### United States Patent and Trademark Office

#### Examiner's Amendment

Title: LAUNCH CONTROL OF HYBRID ELECTRIC VEHICLE HAVING A

TORQUE CONVERTERLESS DRIVELINE

Figure 1

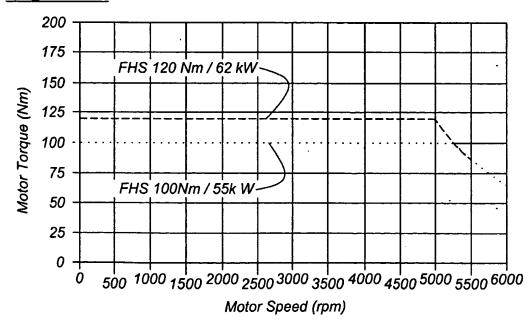
The following changes to the drawings have been approved by the examiner and agreed upon by applicant: In figure 2, "FO" must be changed to "FC", and a line must be added between shaft 22 and the unlabeled member connecting clutches DC and FC. In figure 3, "26" must be changed to "20". See the attached two sheets of marked up drawings indicating the above changes. New formal drawings incorporating these changes are now required.
